APPENDIX F Addtional Non-RAI Requests (SEIS Figures)

PURPOSE:

This Index of Change documents the modifications requested by the NRC per the additional non-RAI information needs. The following methods are a listing of the specific RAI requests and the modifications made to the original application figures in response to those requests.

25-Year Wind Rose Antelope Mine

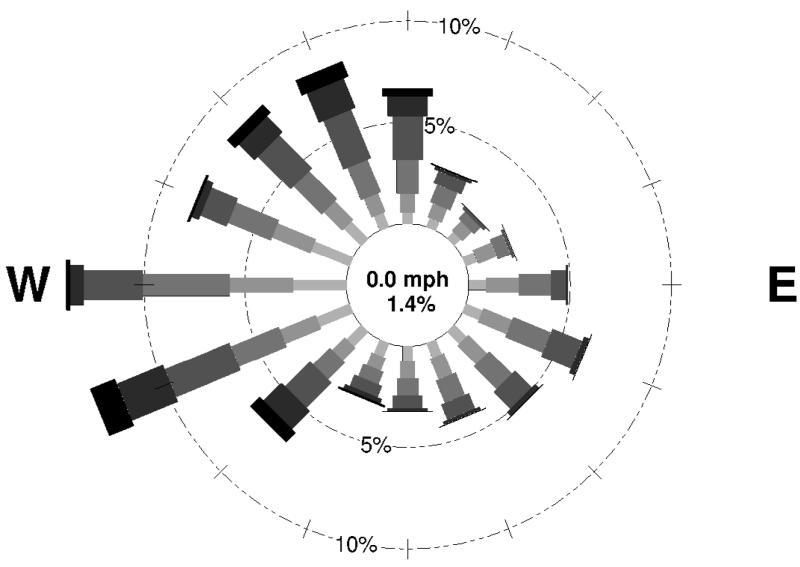
- Change to b/w. Increase size of labels, legend text and symbols, and figure text for readability.
- o Add gradient for wind rose

No changes, aside from those listed above
